ADDENDUM

No. 03 Date: 9/11/2024
Project No. 0020711.01 Attention: Leonard D'Souza
Project Name: Princess Margaret Cancer Centre
Stem Cell Transplant 2, MHC, MHDU, DSC
Address: University Health Network
610 University Avenue
Toronto ON

This Addendum forms a part of the Bidding and Contract Documents and modifies the original issued Bidding Documents (dated August 13, 2024) for the above titled project, as indicated below, and is hereby incorporated into the Contract Documents as part thereof.

G0501

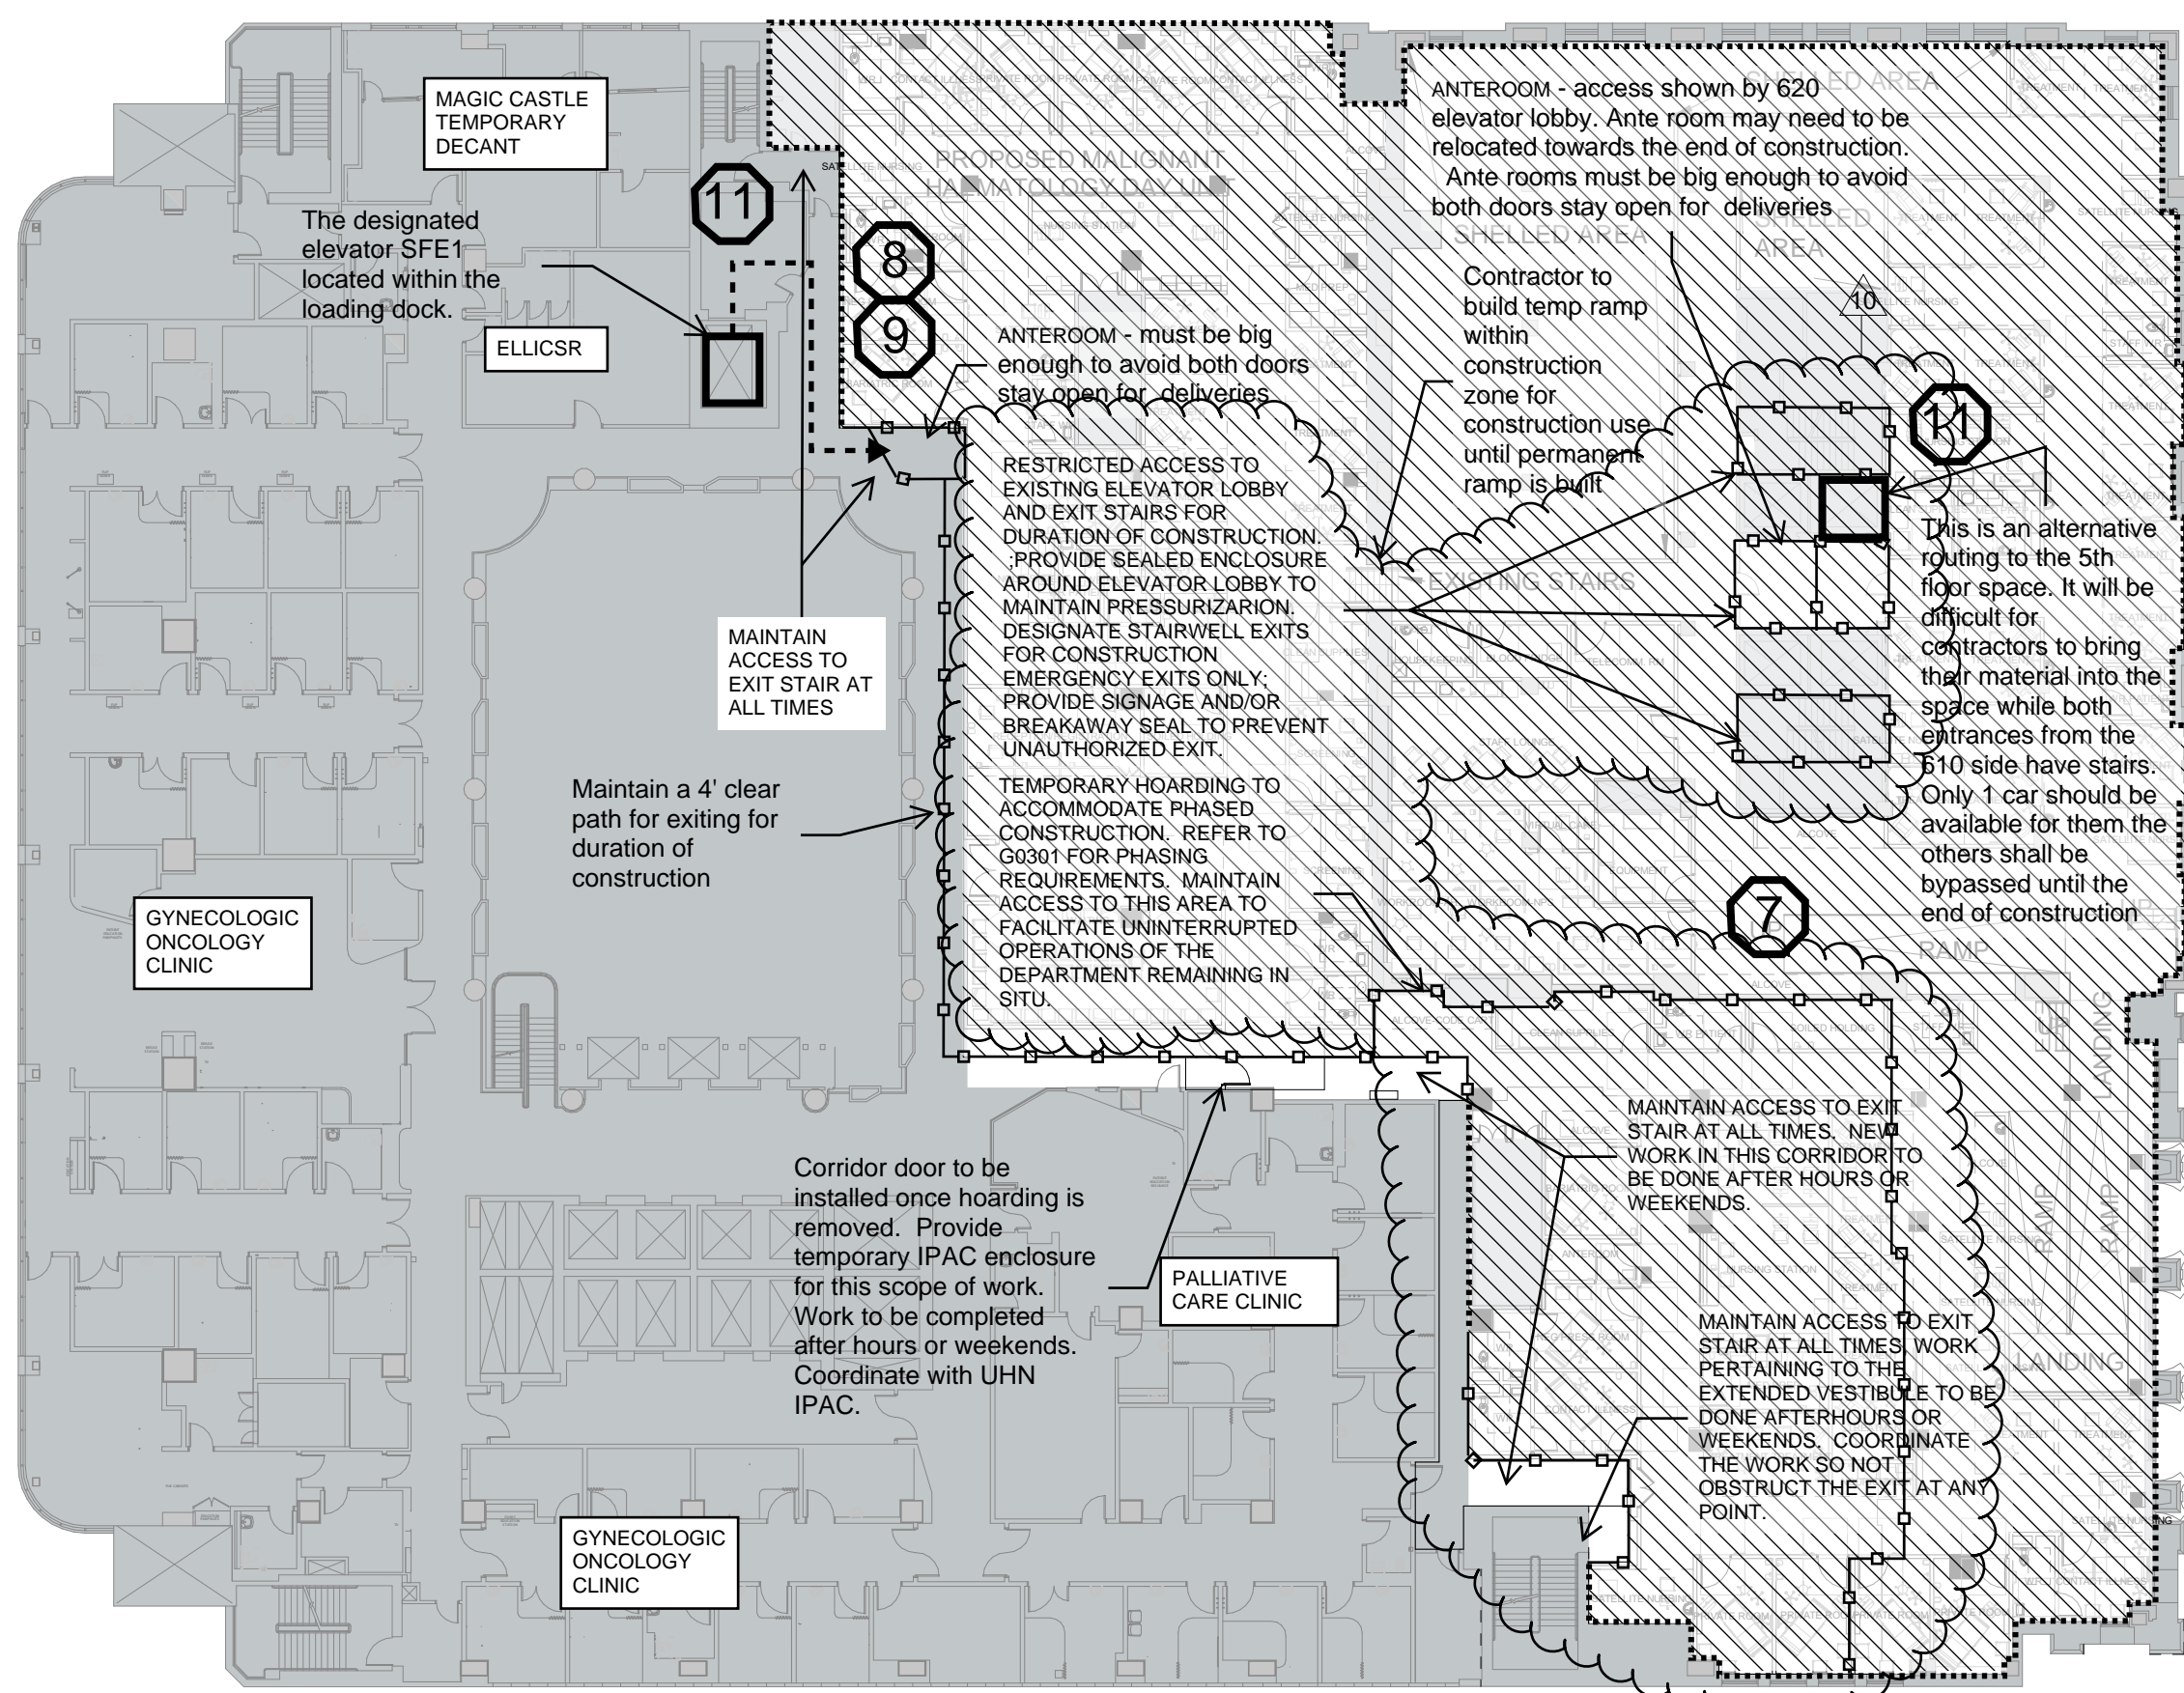
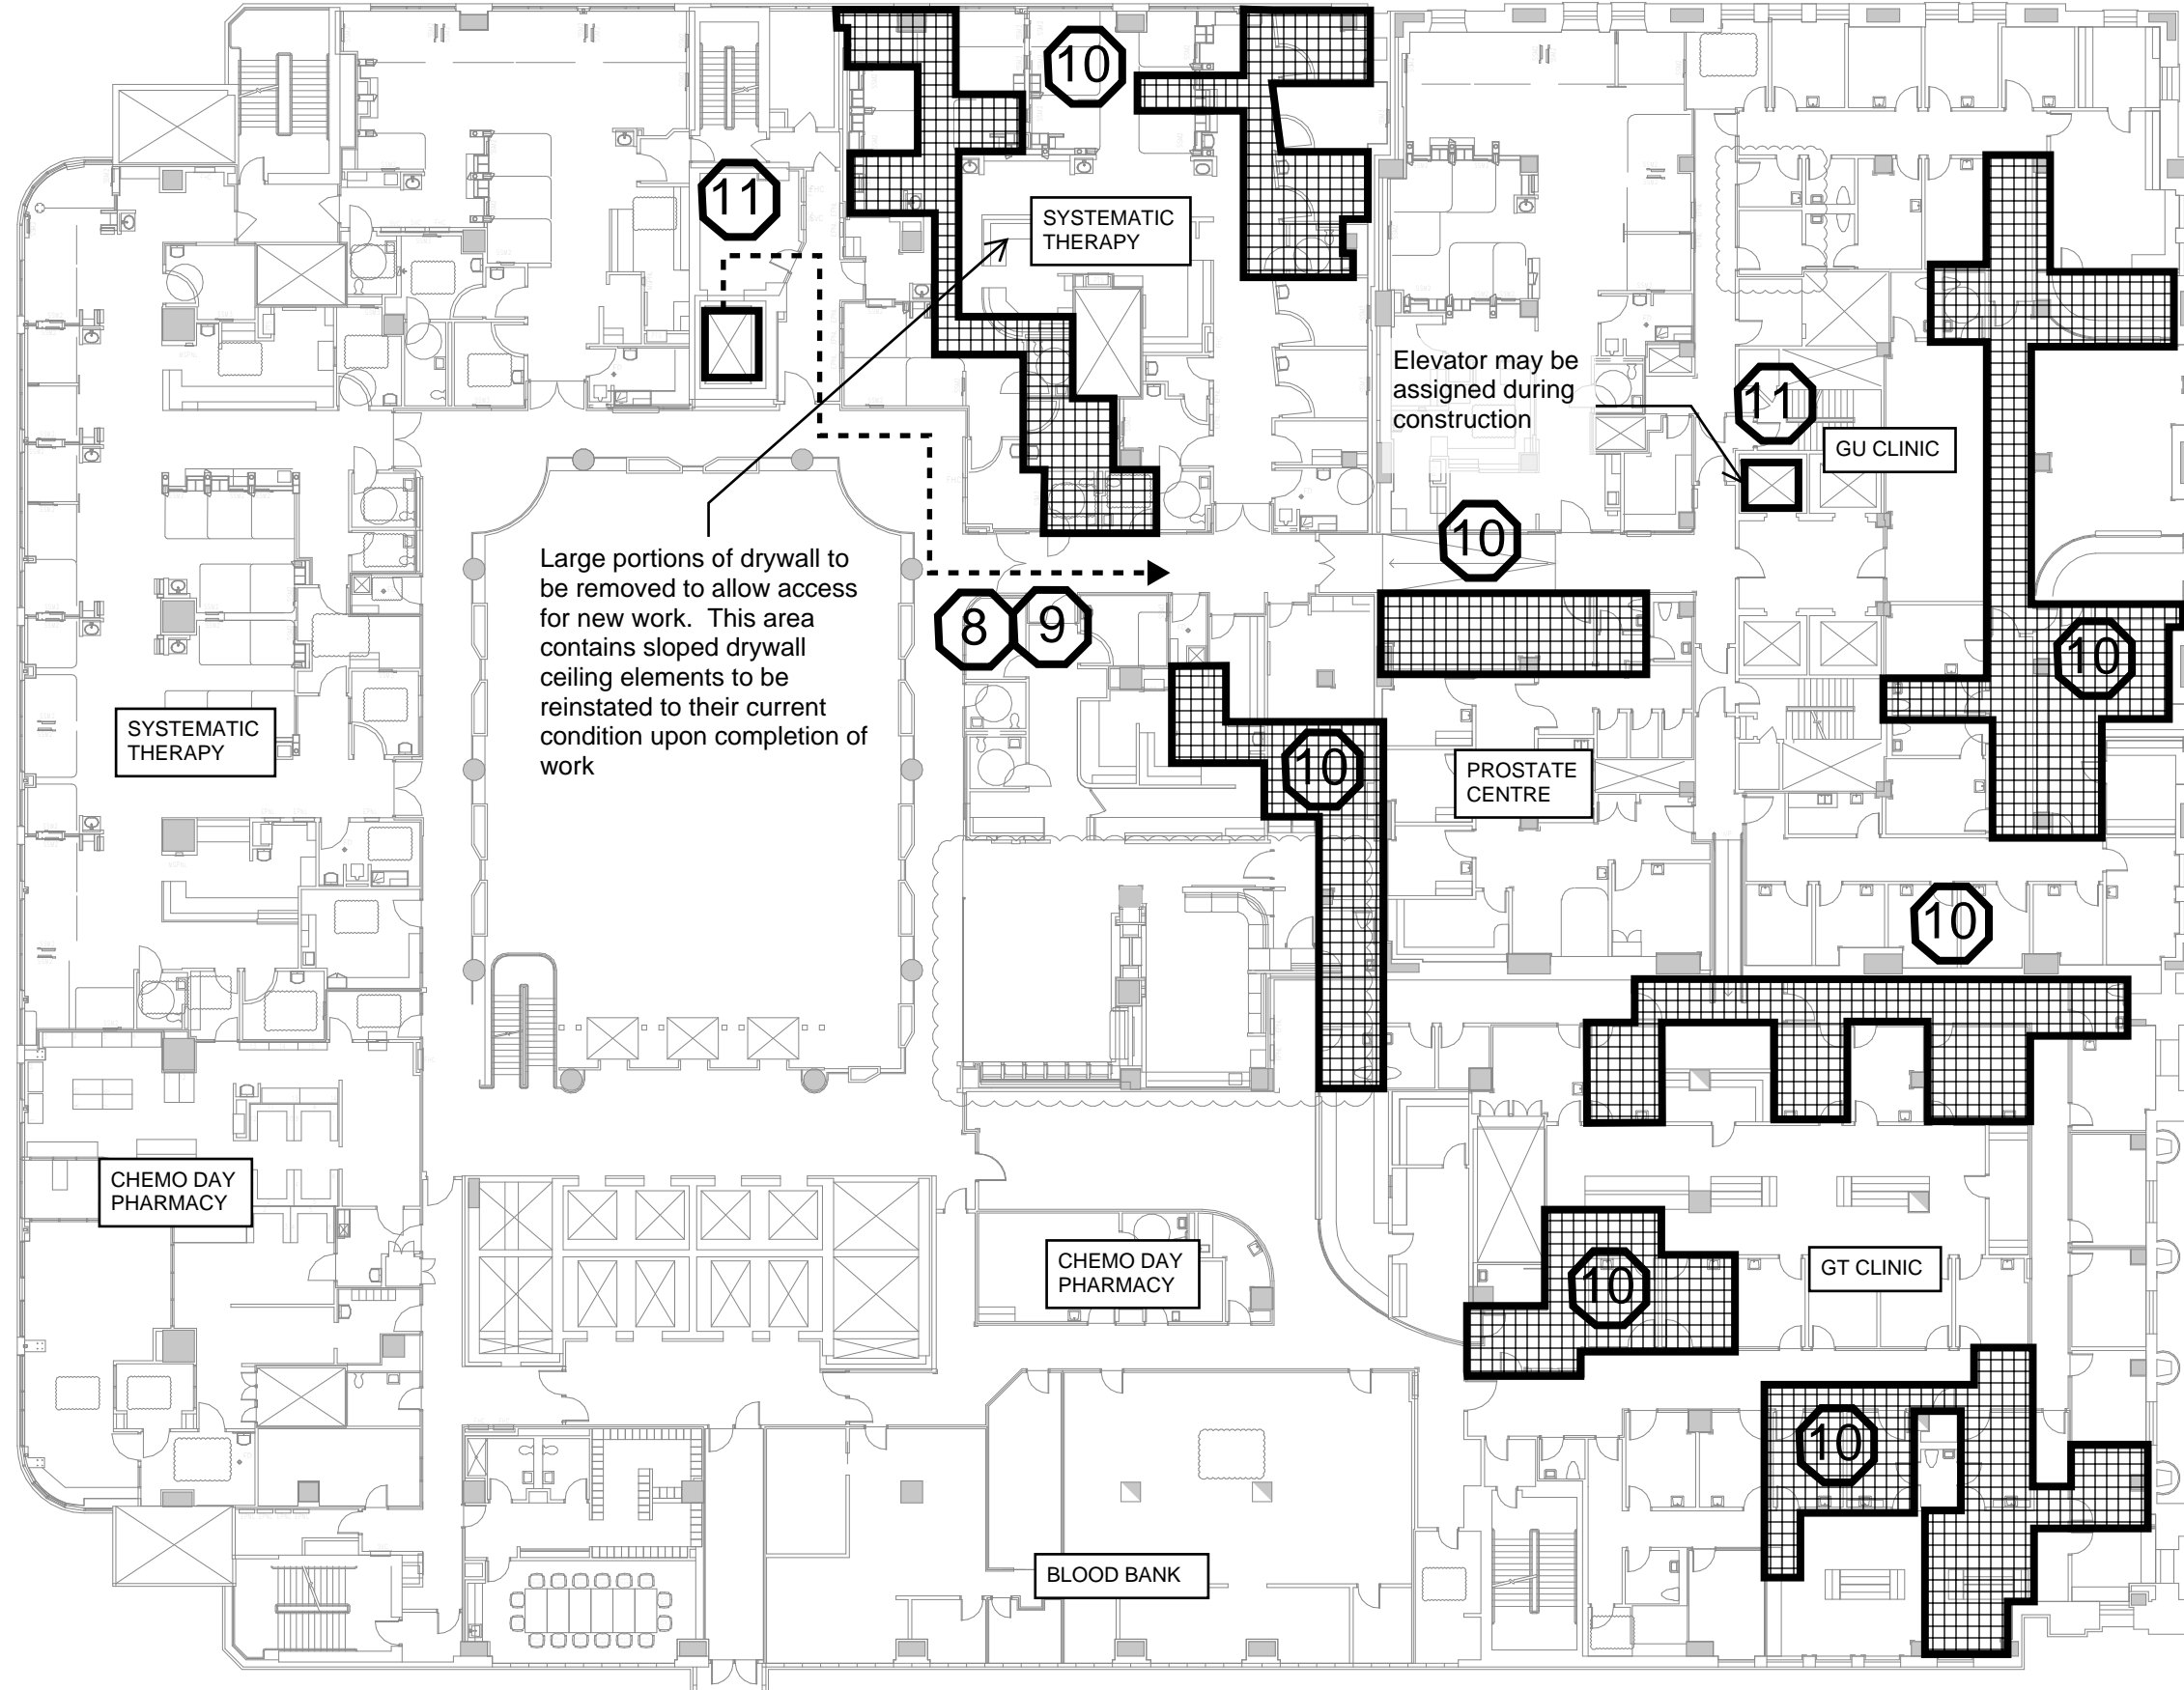
DRAWING G0501 – CONSTRUCTION CONTROL PLANS

Revised legend, added notes for travel paths, exit stairs, compactor in loading, added hoarding for phased construction on Level 5 MHDU.
